Subject: Engineering, Procurement and Construction (EPC) Contract for Renovation and Modernization of Existing Navigational Lock at Farakka, West Bengal.

Reference: IN-IWAI-350002-CW-RFB-2

CPP Portal Tender no: 2023_JMVP_782597_1

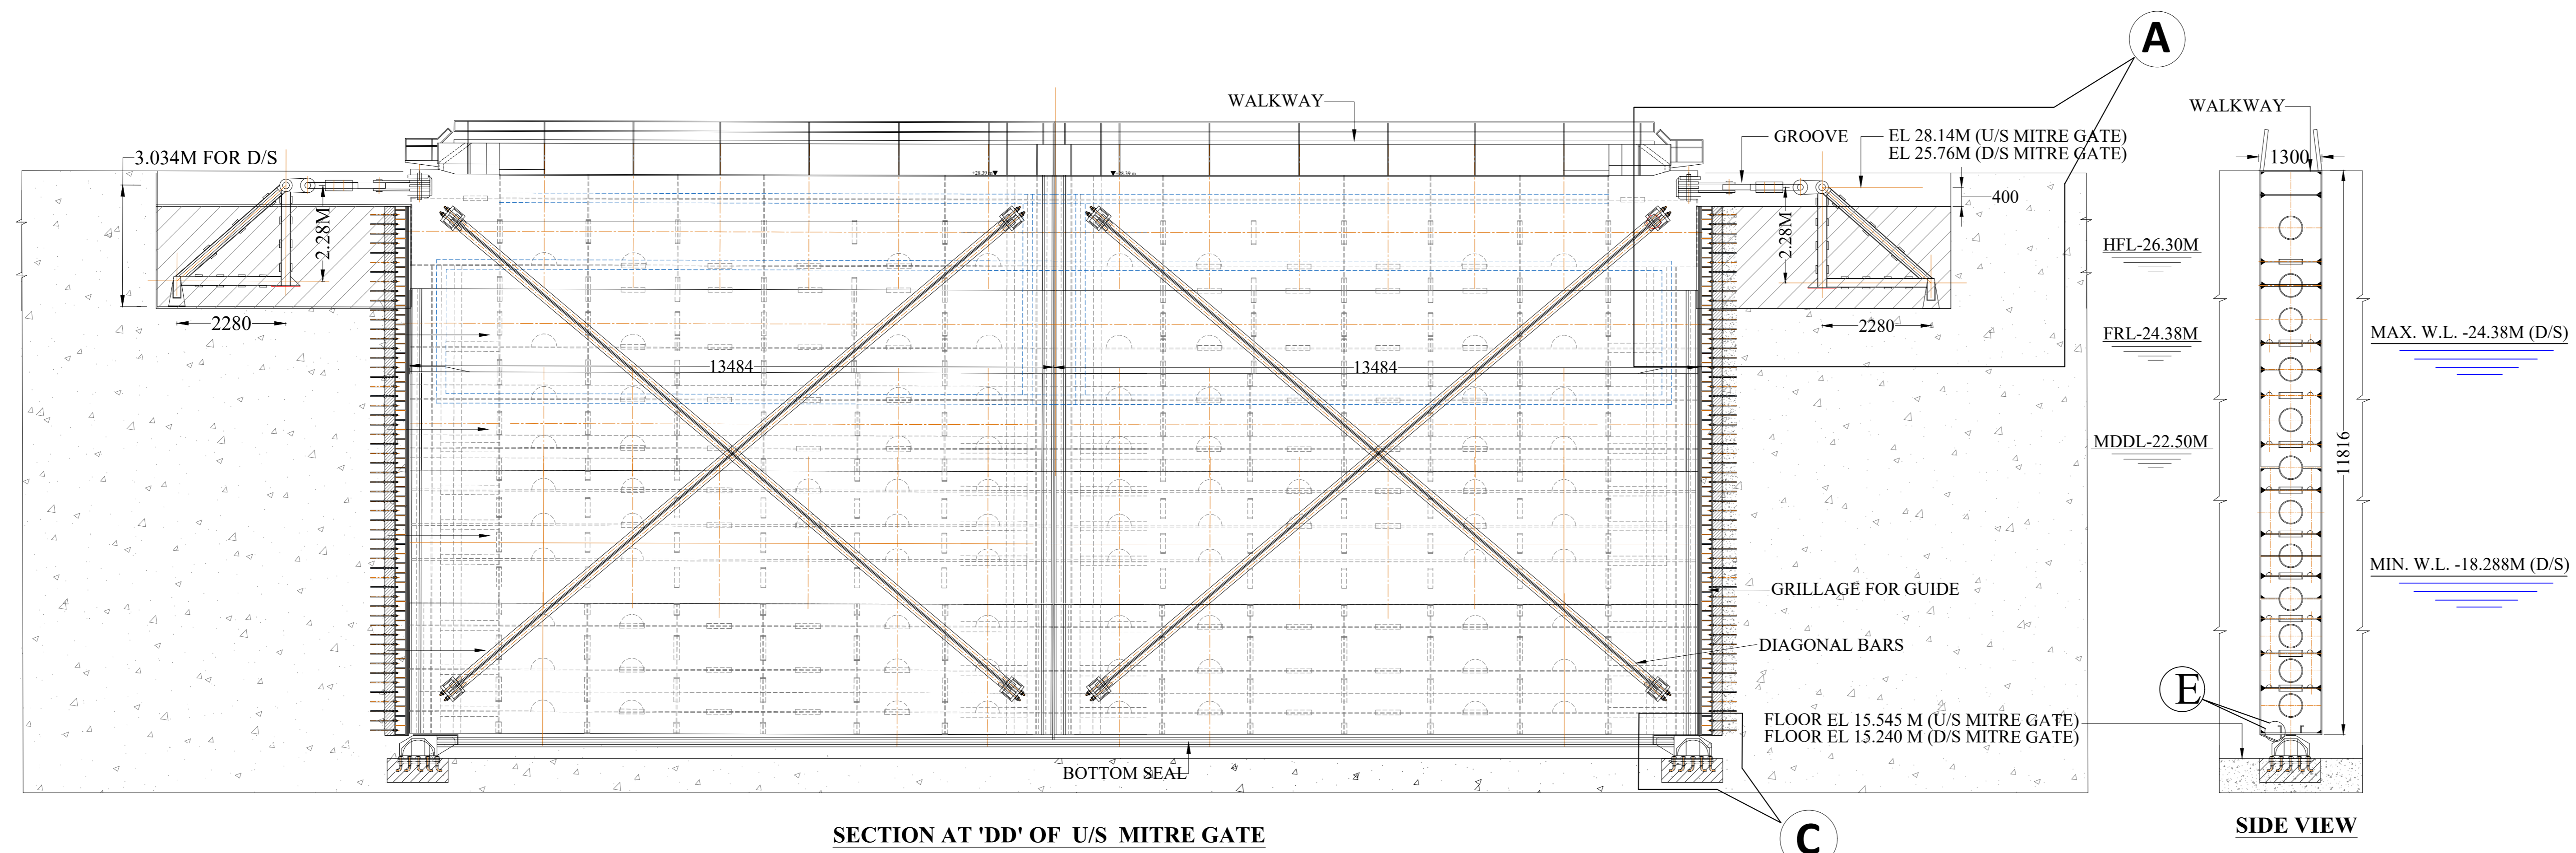
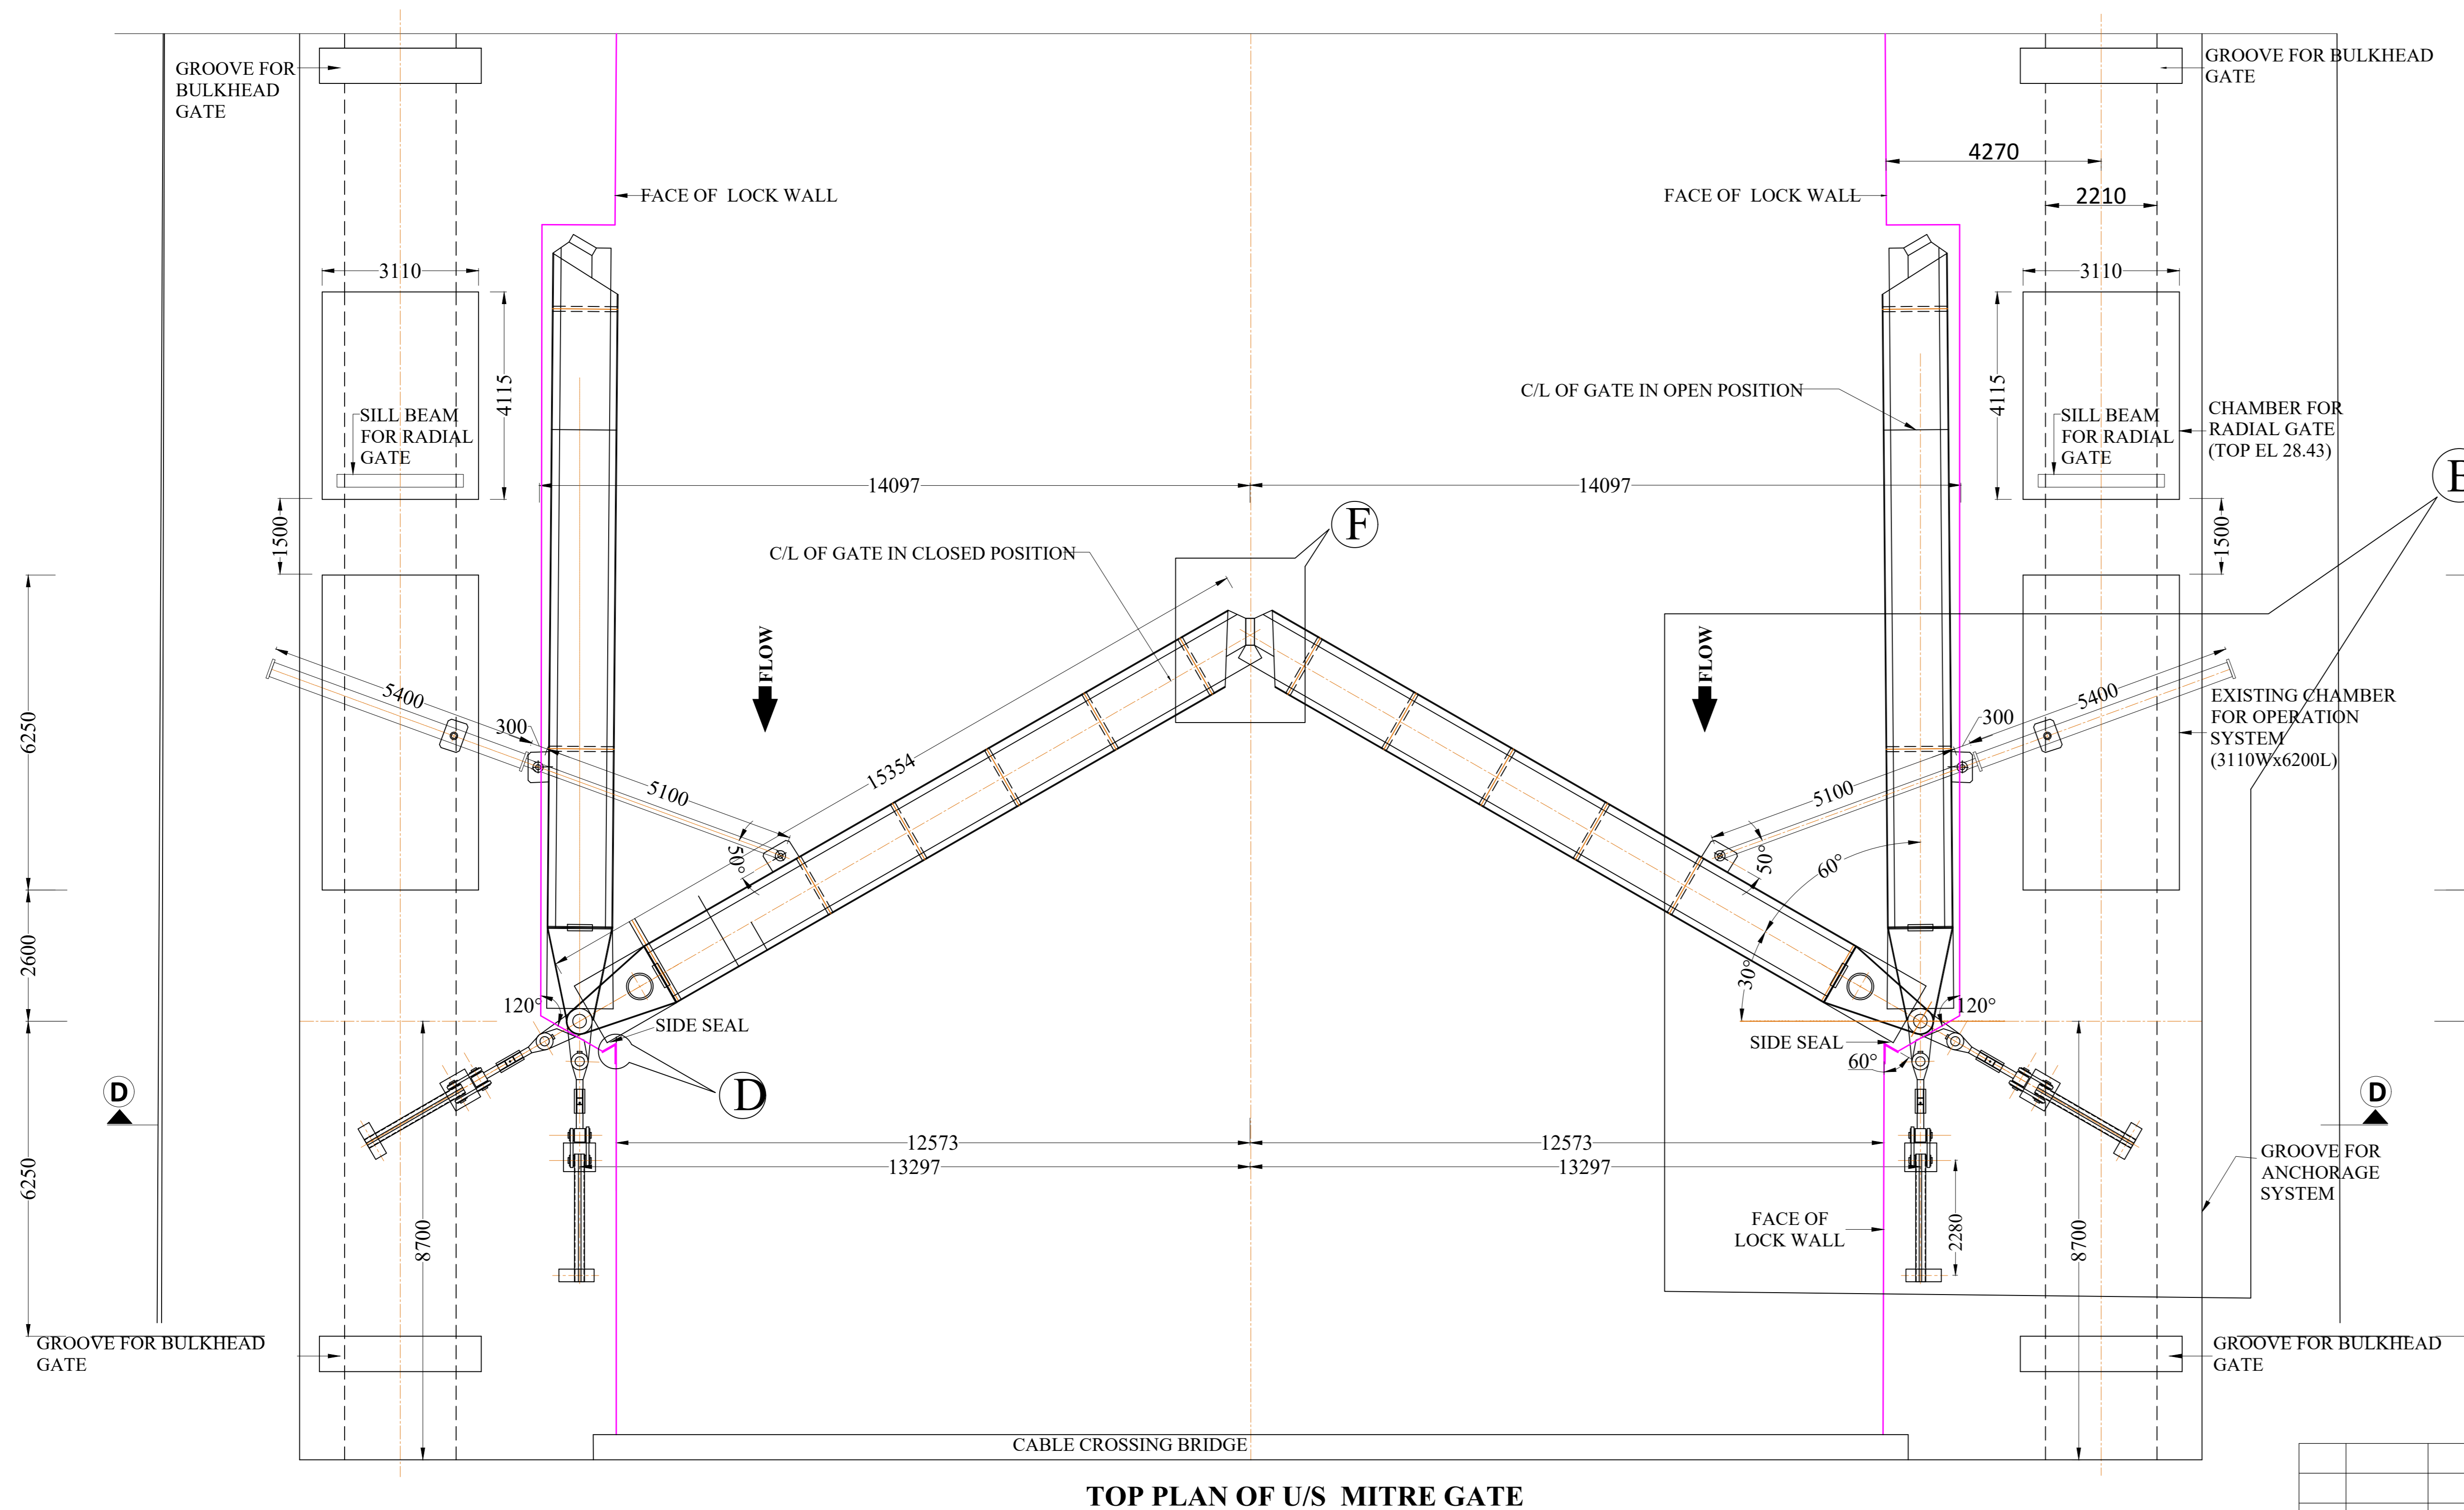
IWAI shall confirm bidder understanding.	
30	Volume 2: Technical Specifications-Tender Drawing)"GENERAL ARRANGEMENT DRAWING AND DETAIL OF MITRE GATE OF EXISTING NAVIGATION LOCK, ENL007-SH1	Recess space	<p>The existing mitre gate width provided is 1.3 m .</p> <p>Recess space provided in concrete in open condition is 1.5 m.</p> <p>-</p> <p>Below are the factors needs to be considered for fixing the width & recess space of the mitre gate.</p> <p>-</p> <p>Free space behind the gate to allow water to flow back behind the gate when opening or closing the gate. Too little space behind the gate will have a ‘suction’ effect and the hydraulic cylinder would need to provide very high forces to open/close the gate or move very slowly.</p> <p>-</p> <p>Wood / UHWMPE protection fender beams on the face of the gate needs to be considered.</p> <p>-</p> <p>Minimum bottom air chamber width, Strength and fatigue checks with relation to the required loading conditions etc., needs to be accounted for while deciding the mitre gate width.</p> <p>-</p>	<p>Tender conditions prevail.</p> <p>The Mitre gate shall be designed to have the thickness to fit within the recess space provided in the existing structure.</p>

<p>With the specified Design difference head, ship Impact conditions - extensive concrete works on mitre gate recess is foreseen which may also affect the underground duct. This approach of limiting the recess space with the specified design condition is not recommended by gate designer.</p> <p>-</p> <p>Alternatively, it may be possible to design a gate to fit the 1.5m recess but other specified design requirements (such as retaining of full water head (10.8m), ship impact, opening time) will probably need to be dropped / altered.</p> <p>-</p> <p>IWAI could review and advise us.</p>	
31	Volume 2: Civil Structural 2.1.2, Page No- 43	<p>Design Life The permanent works shall be designed and constructed to give the following design lives:</p> <ul style="list-style-type: none"> ➤ Locks - 50 years (As per PIANC 2011 workshop) ➤ Bank protection works - 50 years ➤ Fenders, Bollards and ladders - 8 years ➤ Buildings - 50 years <p>Above design lives are defined as a period within which the asset will</p>	<p>1.New structures (residential quarters, Toilet Block, Security Office cum check post, caisson gate parking bay -design life shall be considered 50 years.</p> <p>2.Retrofitted /modernized structures such as lock and control building -design life as specified will not be applicable and overall strength and stability shall be client's scope.</p>	<p>The part of the civil structures of Lock shall be designed for its life for 50 years. Tender conditions prevail.</p>

<p>AND DETAIL OF MITRE GATE OF EXISTING NAVIGATION LOCK "ENL007-SH1</p>		<p>width & recess space of the mitre gate.</p> <ul style="list-style-type: none"> - Free space behind the gate to allow water to flow back behind the gate when opening or closing the gate. Too little space behind the gate will have a 'suction' effect and the hydraulic cylinder would need to provide very high forces to open/close the gate or move very slowly. - Wood / UHMWPE protection fender beams on the face of the gate needs to be considered - Minimum bottom air chamber width, Strength and fatigue checks with relation to the required loading conditions etc., needs to be accounted for while deciding the mitre gate width. - With the specified Design difference head, ship Impact conditions - extensive concrete works on mitre gate recess is foreseen which may also affect the underground duct. This approach of limiting the recess space with the specified design condition is not recommended by gate designer.

<p>- Alternatively it may be possible to design a gate to fit the 1.5m recess but other specified design requirements (such as retaining of full water head , ship impact , opening time) will probably need to be dropped / altered.</p> <p>- IWAI could review and advise us.</p>	
67	Volume II: Technical Specifications, Volume - 2 Clause no 2.3.9 pg 81 of 571	Floataion and Stability – Caisson Gate, The gate shall be capable of being ballasted for de-ballasted in 30 minutes or less.	This is applicable to gravity system and not applicable to pumped system.	Clause no 2.3.9 at page no 81 of Vol-2 may be read as: “Floataion and Stability – Caisson Gate: the gate shall be capable of being ballasted or de-ballasted in 30 minutes or less.”
68	Volume II: Technical Specifications, Volume - 2 Clause no 1.1.4, Table no 1.1, pg 14 &15 of 571	Bollards – eight (8) numbers. floating type fourteen (14) numbers fixed type	The existing Fixed and floating Bollard capacity of 5 ton. Bidder presume the same capacity shall be provided.	Clause No. 4.21.3.1 at page no 369 of Vol-2 may be referred. Tender conditions prevail.

CONSULTANT	NAME SIGN DATE
 PKS FLOODKON JV	DRN
	CHD
	APD
TITLE	JOB. NO. DRG. NO.
POWER SINGLE LINE DIAGRAM OF EXISTING NAVIGATION LOCK, FARAKKA	ENL011

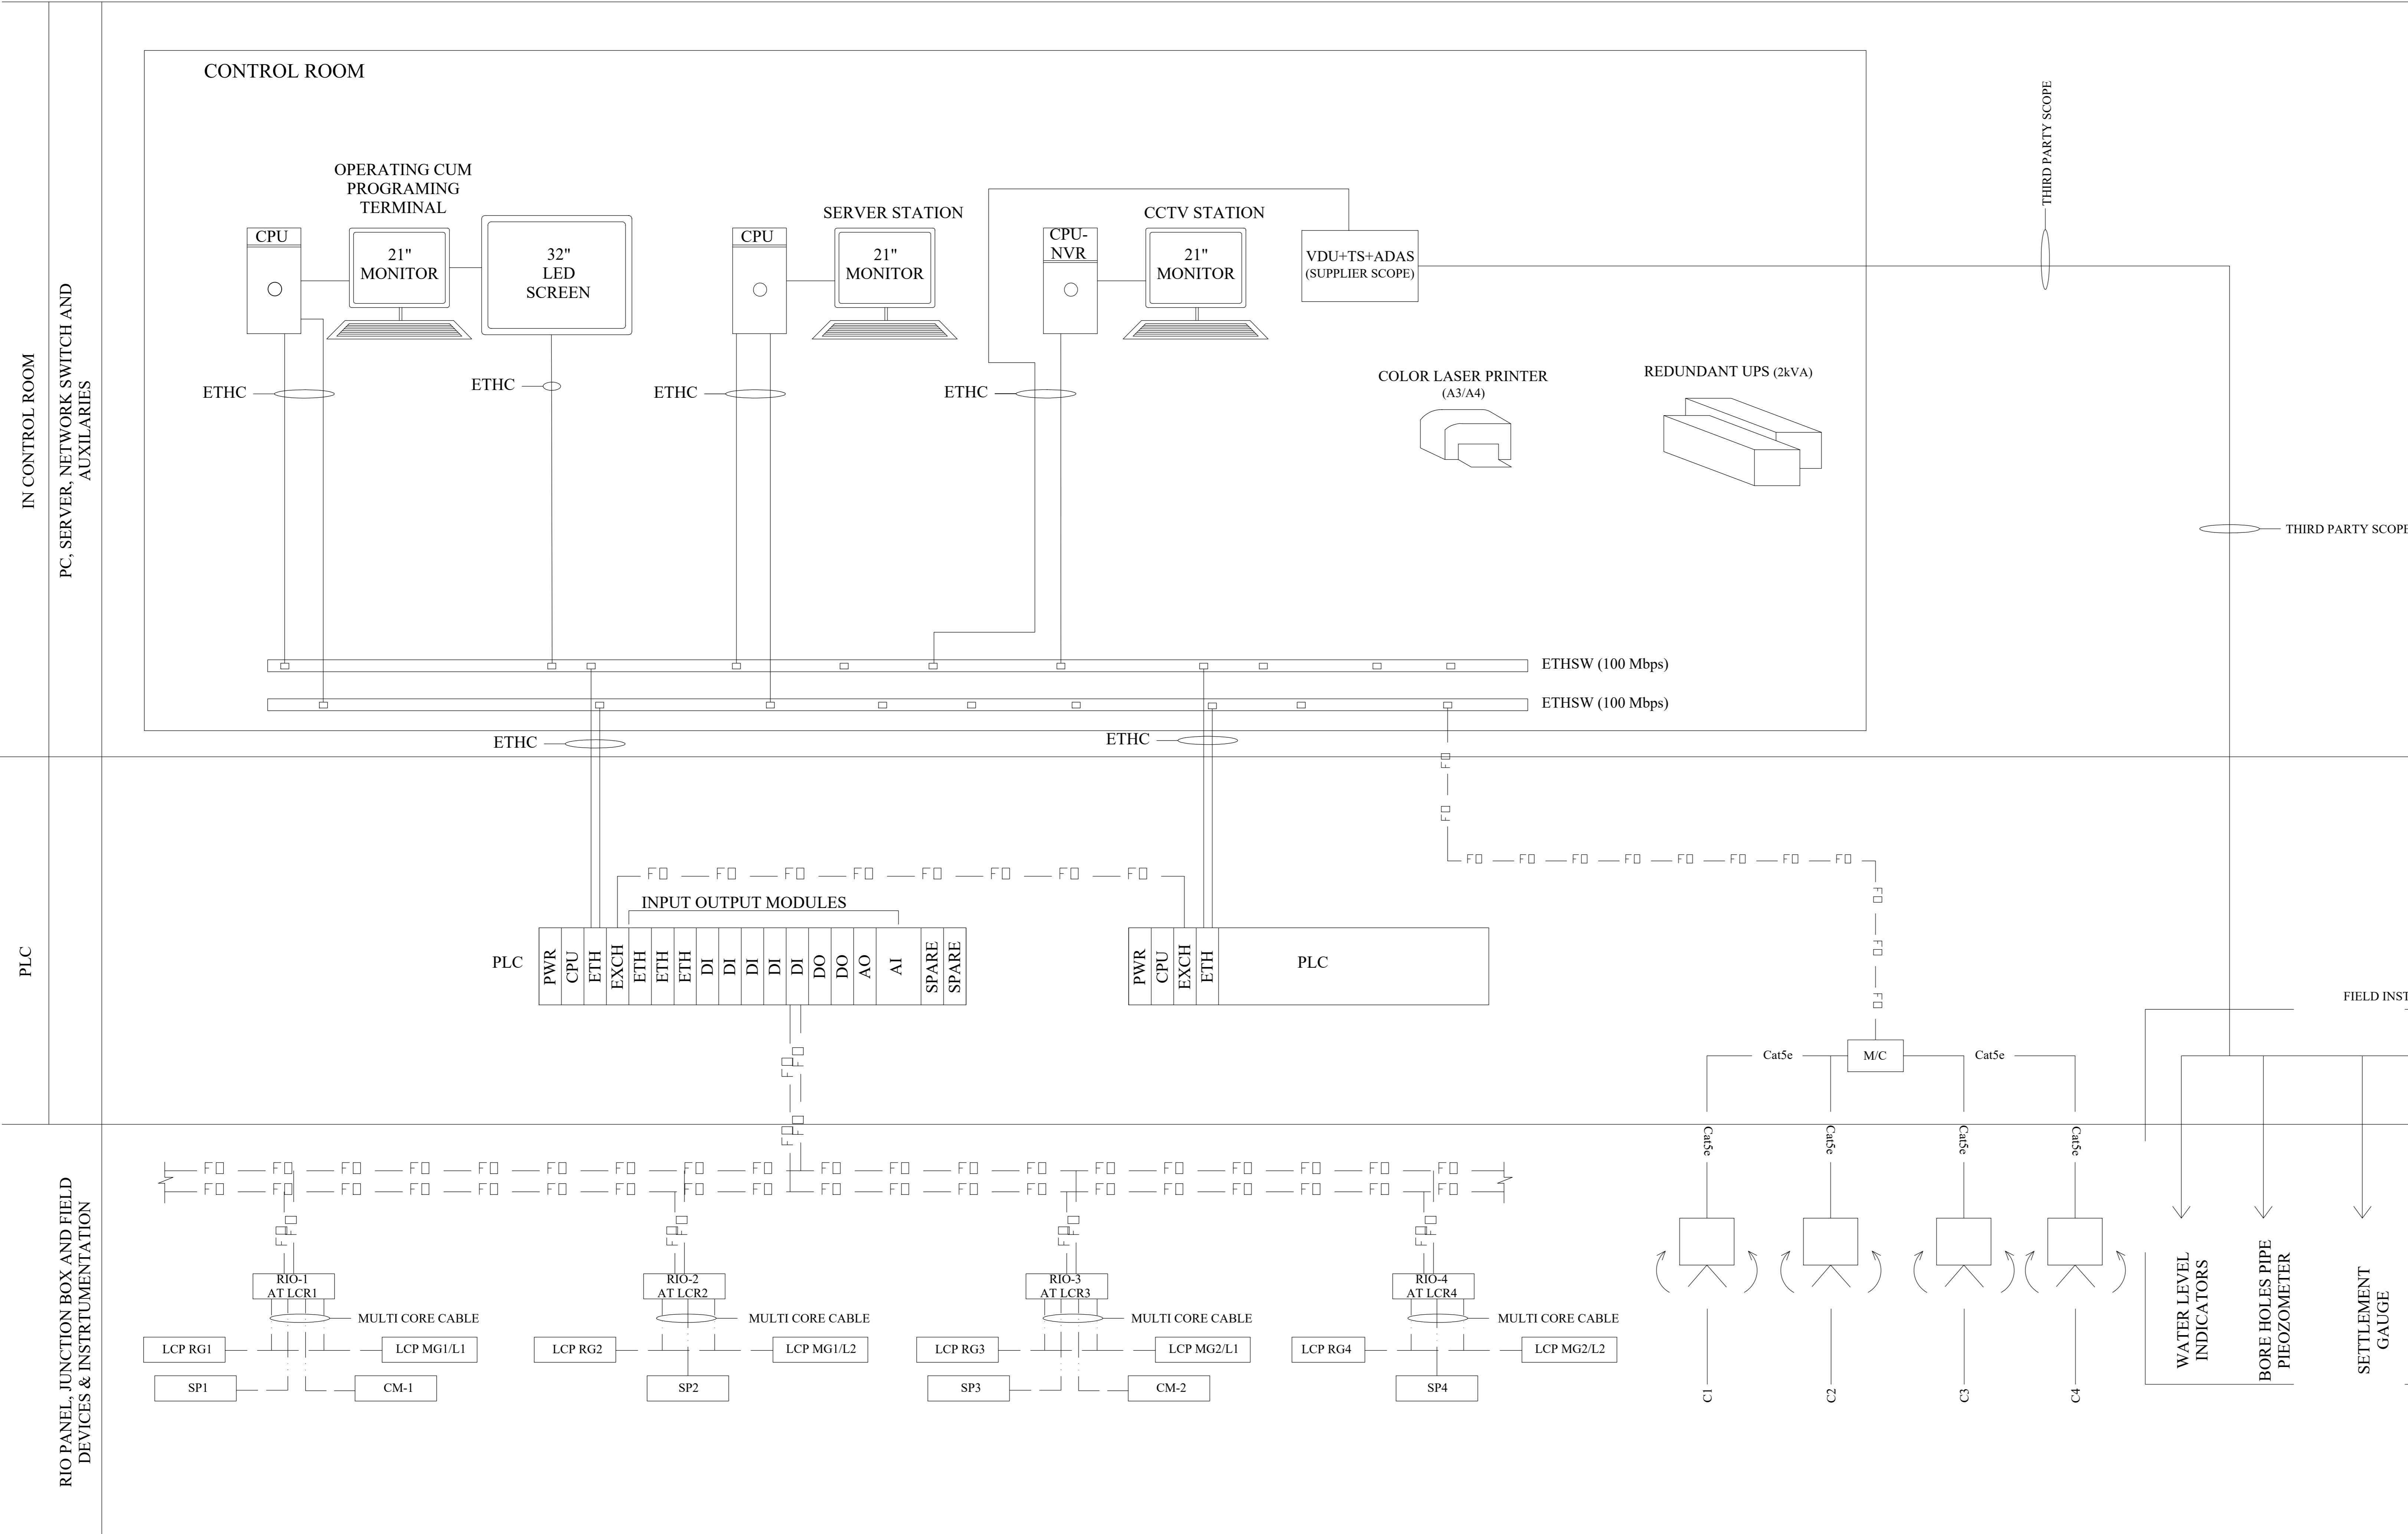
Design pg 79 of 571			
70	Volume II: Technical Specifications, "BULKHEAD GATES 6.5.3 Guide Rollers" pg 543 of 571	Guide rollers shall be provided at the sides of the gates both near the top and bottom.	Bulkhead gates are only used for maintenance of radial gates. They will be used once or twice. The guide strips do not need any maintenance where the wheels are very likely to be rust, stuck and create operational issues. It is recommended to envisage guide strip. Owner shall review and confirm the usage of guide strip.	Tender conditions prevail. Appropriate design shall be done with latest technology.
71	"POWER SINGLE LINE DIAGRAM OF EXISTING NAVIGATION LOCK, FARAKKA (DRG. No: ENL011)" ELECTRICAL Note no.15 & 16	Local Control Room	As per SLD note no.15 & 16, There are 8nos of LCR has been proposed. However as per actual operational requirement 4nos of LCR has been visualized in "Control System architecture for exiting lock (Drg.no.ENL012). Kindly clarify the requirement of additional 4nos of LCR.	Please refer point no 5 of Table 1.1 at page no 14 of Vol-2. The modified SLD (ENL 011_R1) attached as Annexure-A for indicative purpose. However, the contractor shall design the SLD. it is 1 Central Control Room and 4 local control room.
